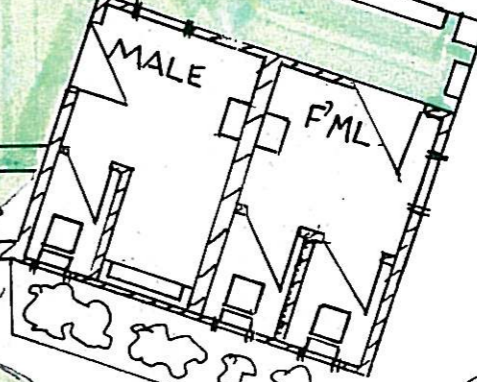
Carpet to floor

Add Wall to Enclose Coolroom & Entry to Bar. 1.6 x 2.9

Delete Entire Bar Area. Expand Restaurant Area

Restaurant entrance to be wider. from 820 to 1640

600 Wide entrance to bar

Bar to be 2.0m x 5.8m with 0.400m bar top. (Front Overhang 0.200m)

600 Cupboards to under front of Bar & to Back Wall of Bar with two Stainless Steel Sinks

Bar to be approx 2.0m (13 courses) high and cupboards to be 900 high.

Add Wall with Timber Roof to Enclose Kitchen Area. 1.2m from Kitchen Wall x L-3m

Brick Wall to Cover Rubbish bins

Stainless Steel Benches.
